Re: Explanation of Modifications for:
1950 East Logan Street,
Philadelphia, PA.

Civic Design Review Comments:

1950 East Logan Street

1 BUILDING ENTRY LOBBY PLAN
A3.2 1/4" = 1'-0"

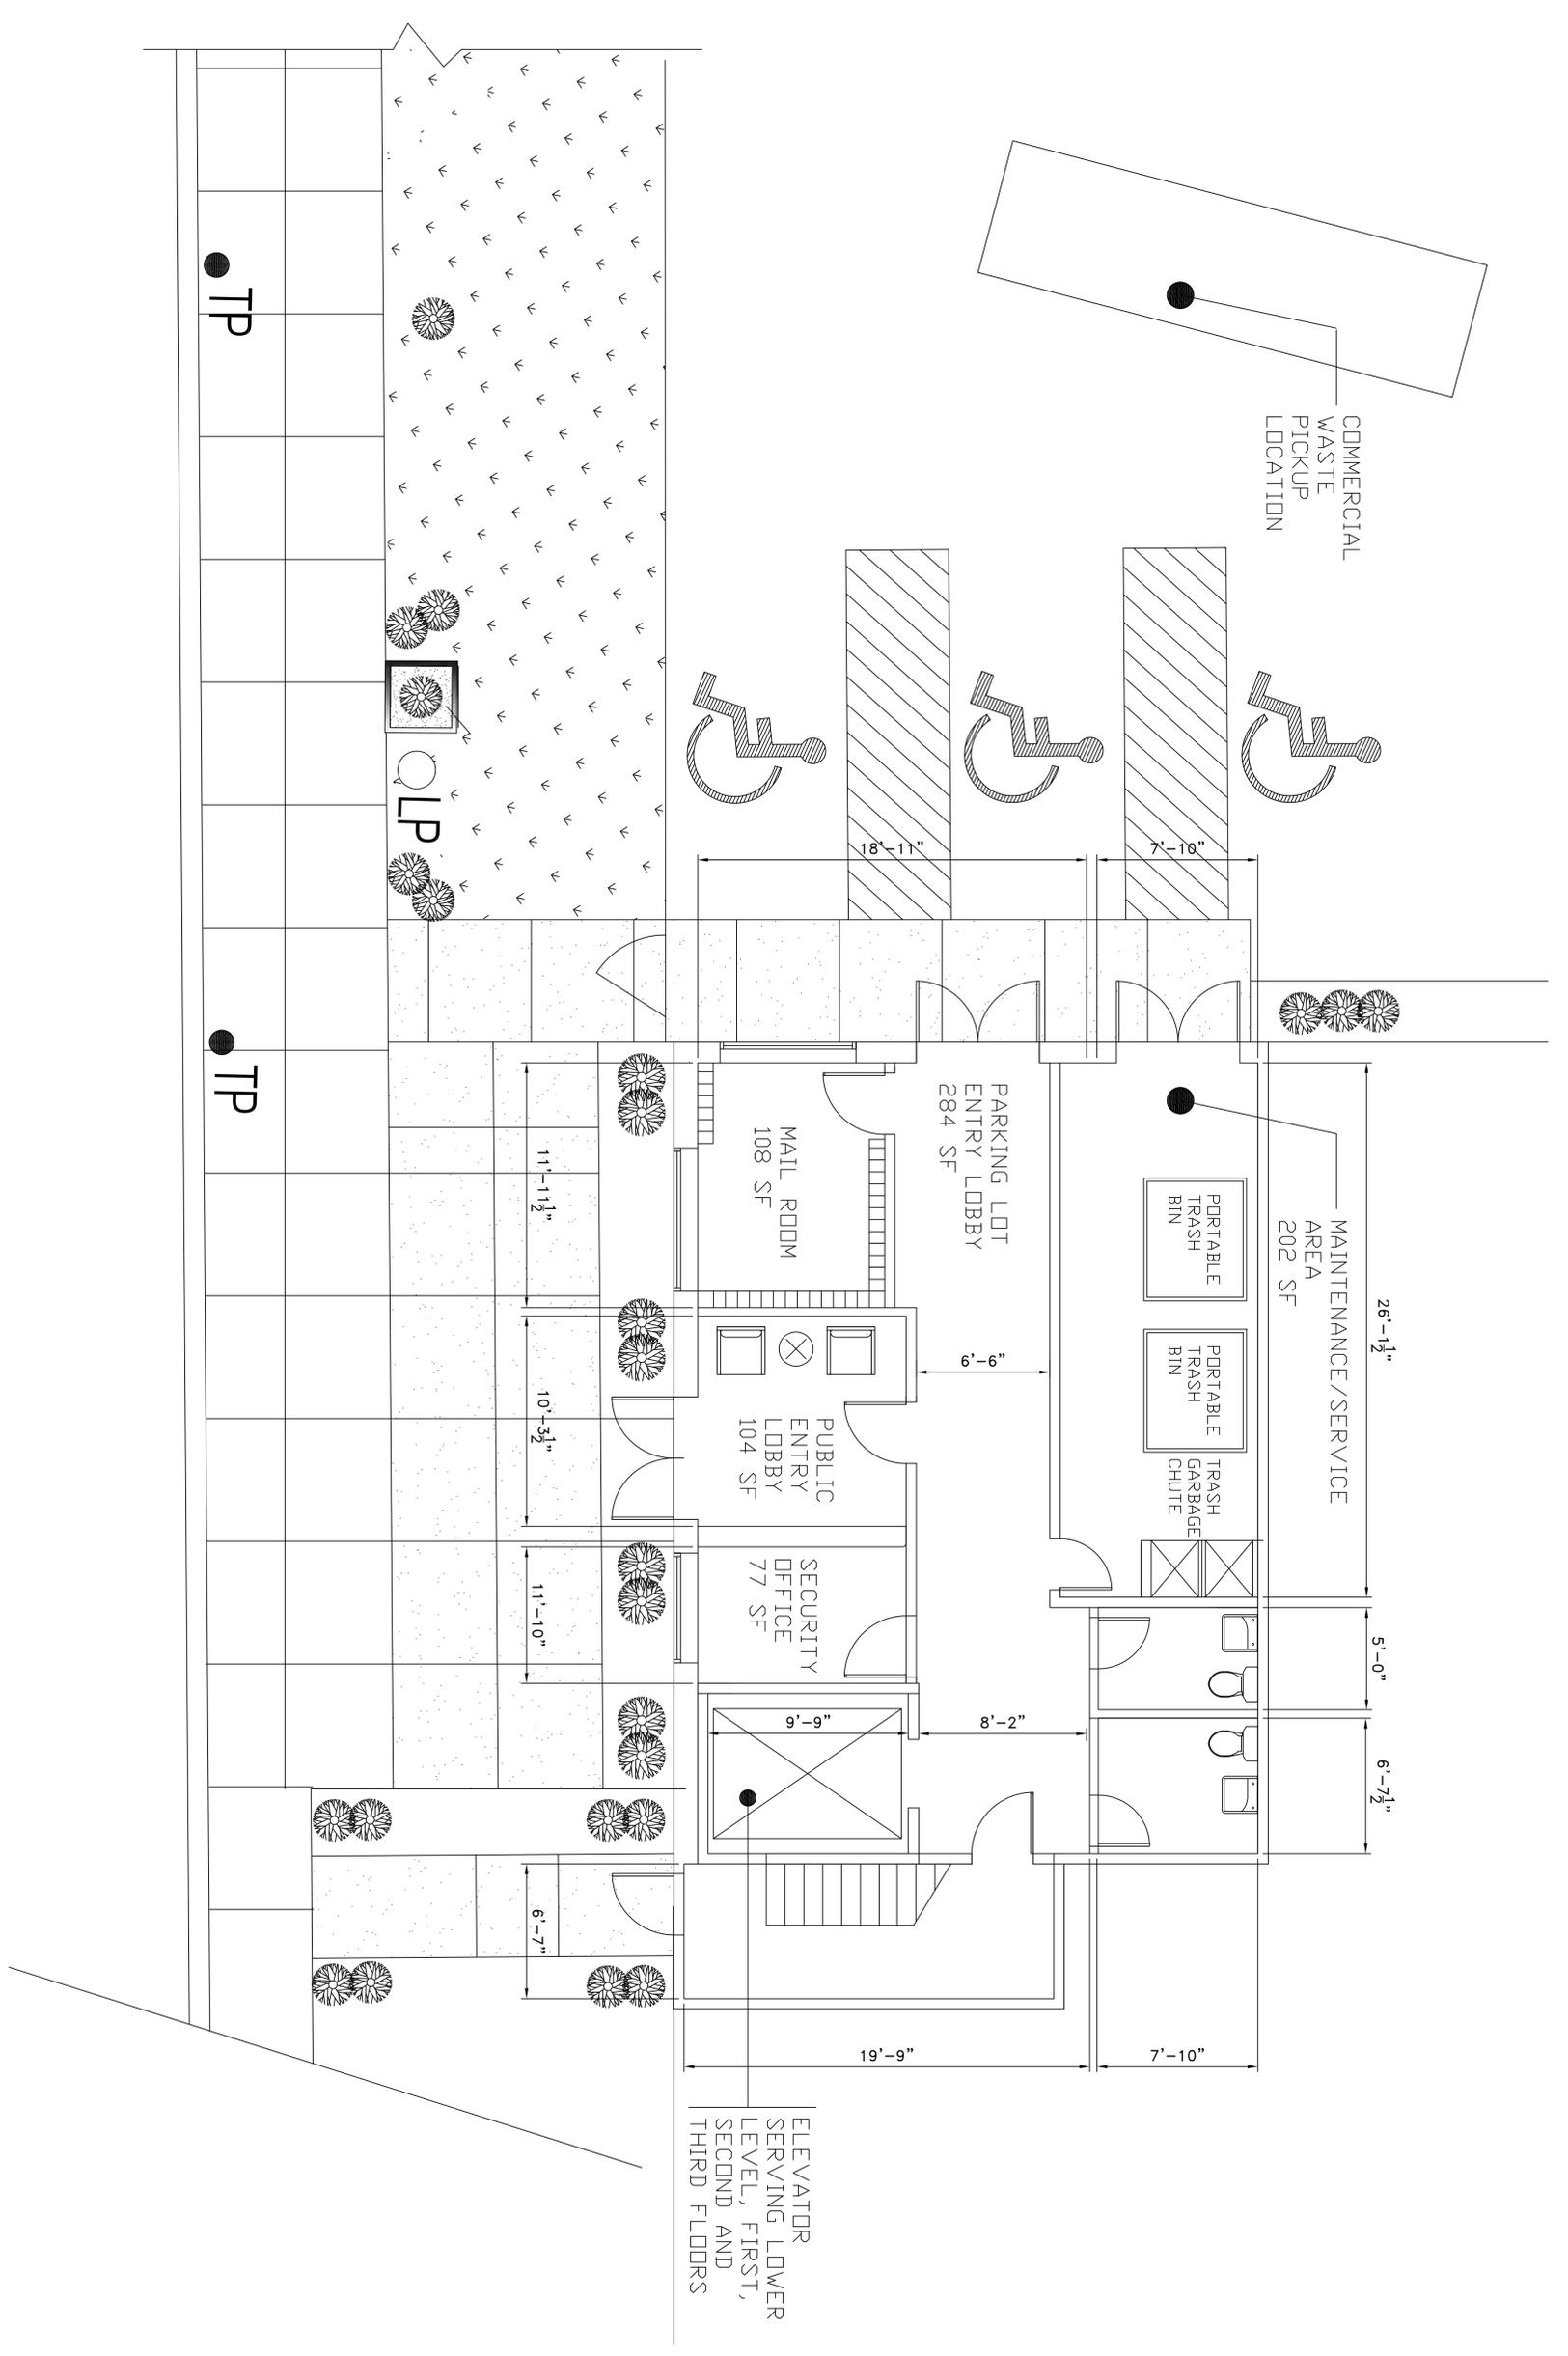
- 7.) Consider a more generous entry lobby with amenities that encourage safe, social behavior. *-Please review the overall plan A1.0, and the enlarged plan A3.2 which show the modifications made to the former retail space into an entry lobby.*

1 FIRST FLOOR PLAN AT ELEVATOR
 A3.3 1/4" = 1'-0"

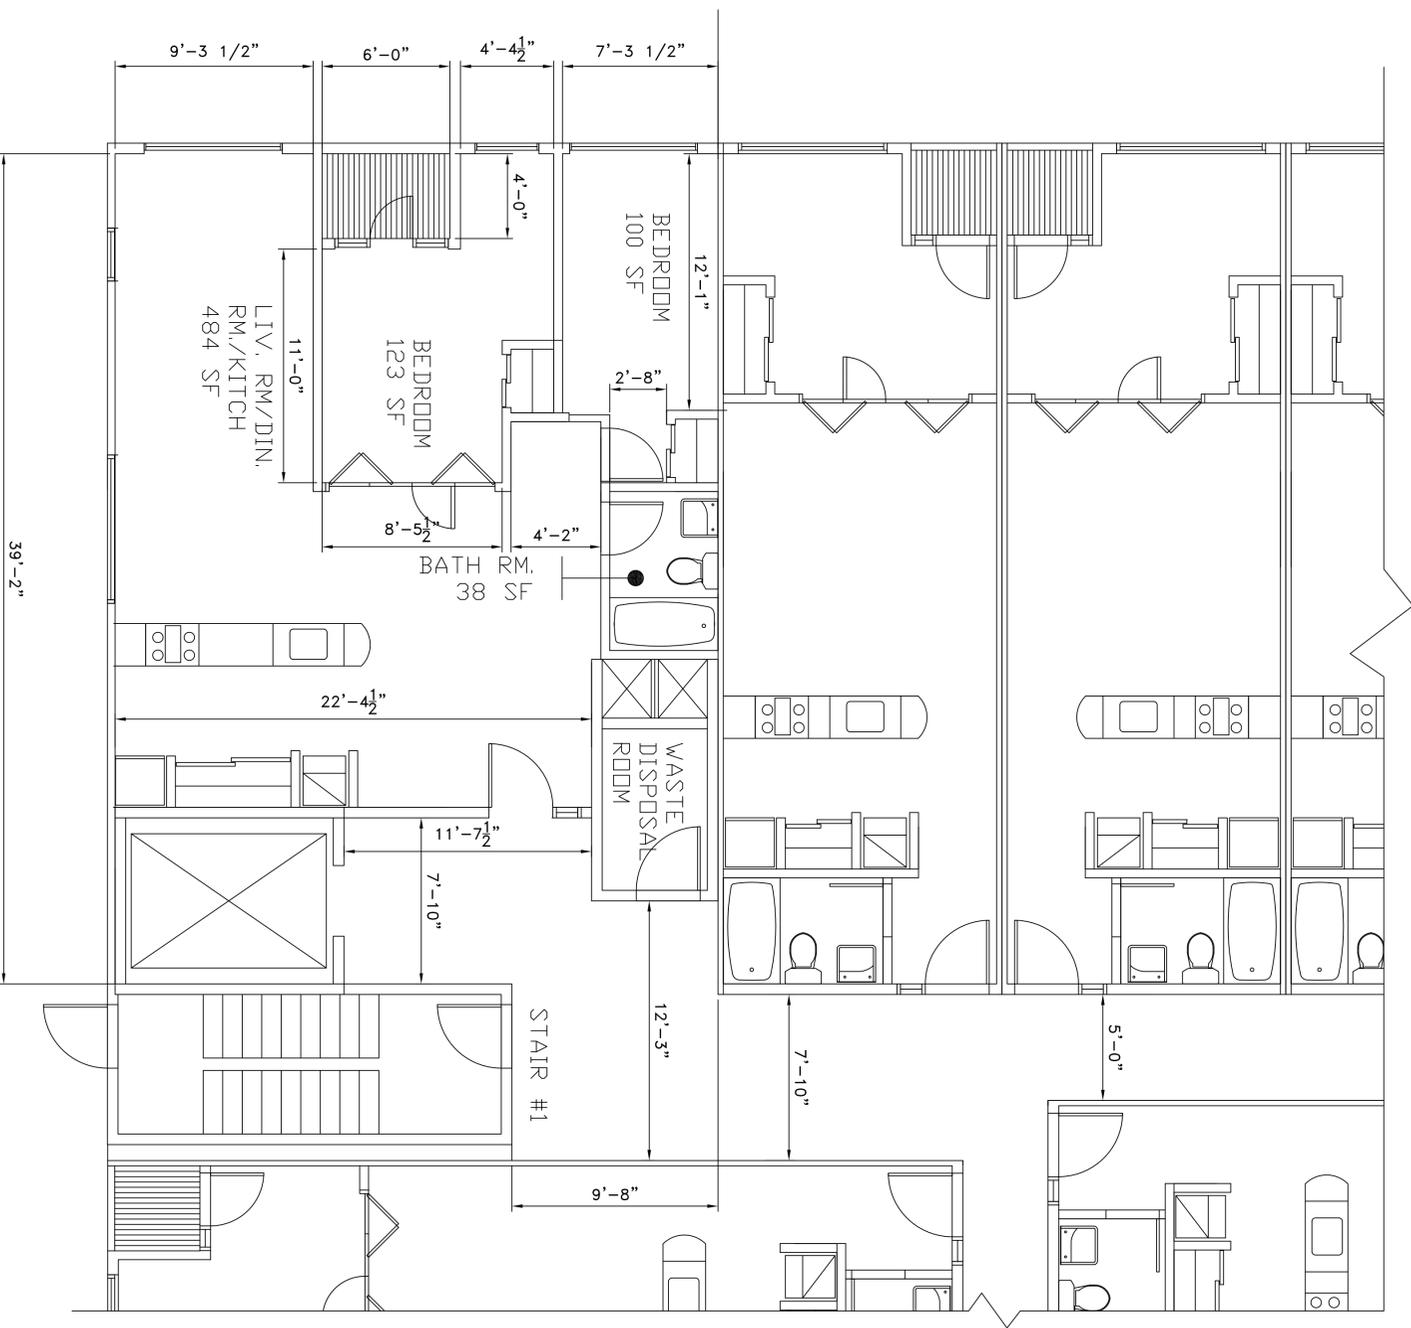
- 4.) Consider making the entire project ADA compliant, all levels of the proposed building. *- Please review the overall floor plans A1.0, A1.1, A1.2, A1.3, and the enlarged floor plans A3.2, A3.3, A3.4 & A3.5 which shows the elevator serving all four levels of the building, and the size of the units which will have enough space to allow for ADA type A & B units as needed on the first, second and third floors.*
